N5222A-02A

S E R V I C E N O T E

N5222A PNA Series Microwave Network Analyzers

Some analyzers are exhibiting unlocked or unleveled errors or other unexpected digital control faults. Analyzers that experience any of the symptoms listed on page 2 of this document must be inspected for a possible return to Agilent to have the system motherboard replaced.

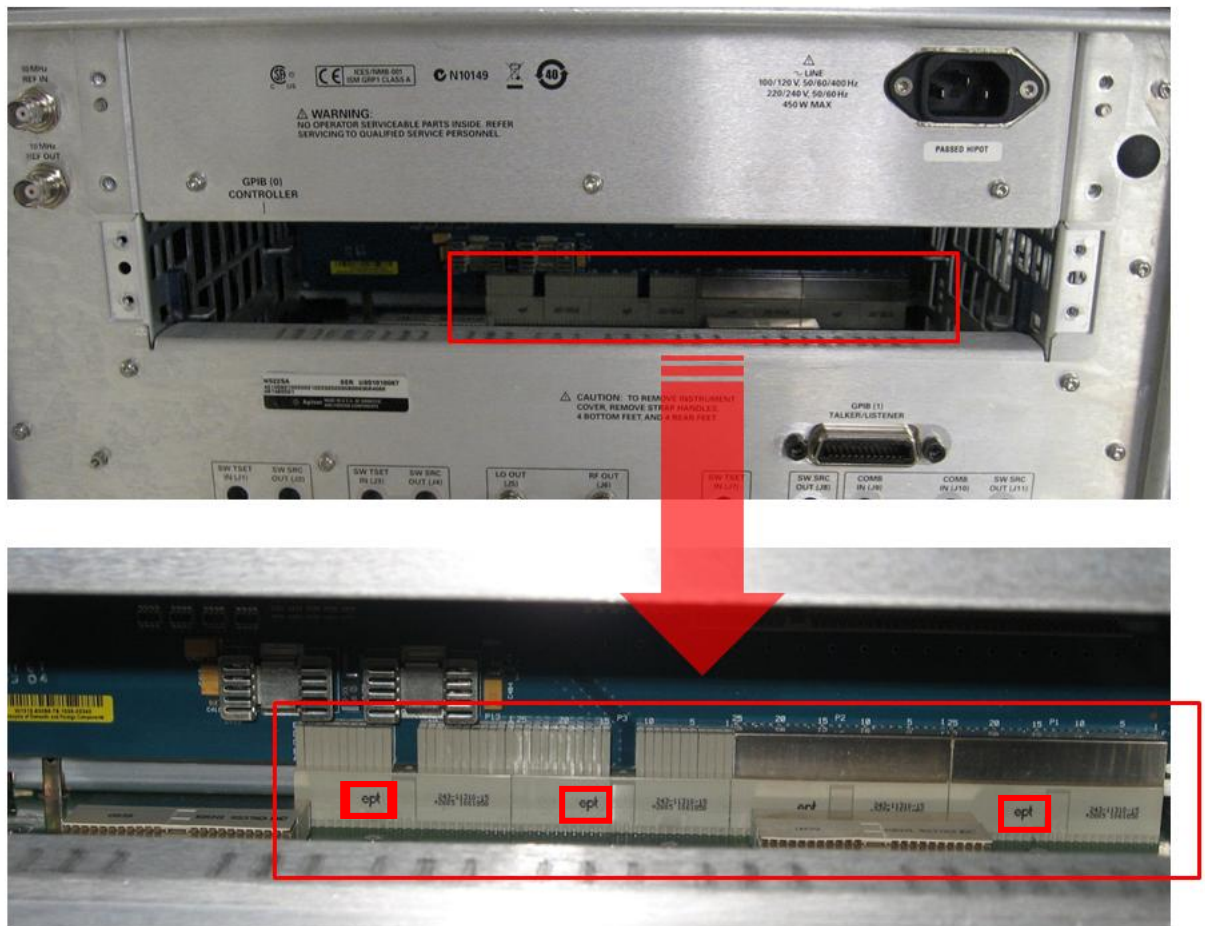
1. Remove the CPU assembly from the analyzer's rear panel. Refer to the PNA Service Guide chapter 7 section titled, "Removing and Replacing the CPU Board Assembly" for removal and reinstallation procedures. To view the online Service Guide, see the numbered list on the next page for instructions.
2. As per the photo below, inspect the system motherboard connector to see if it has one or more "ept" logos.

3. If the connector has one or more “ept” logos, return the analyzer to Agilent for replacement of the system motherboard. If the connector does not have one or more “ept” logos, email ctd-soco_support@agilent.com, providing the analyzer model and serial number and details of the malfunction symptoms.

4. *For Agilent Service Technicians only:* Only new boards without “ept” logos should be installed. Before installing the new board, look to see if it has one or more “ept” logos. If so, email ctd-soco_support@agilent.com, providing the analyzer model and serial number. Wait for further instructions in an email reply. New boards without “ept” logos can be installed. For installation instructions, refer to the PNA Service Guide chapter 7 section titled, “Removing and Replacing the System Motherboard.” To view the online Service Guide, see the numbered list on the next page for instructions.
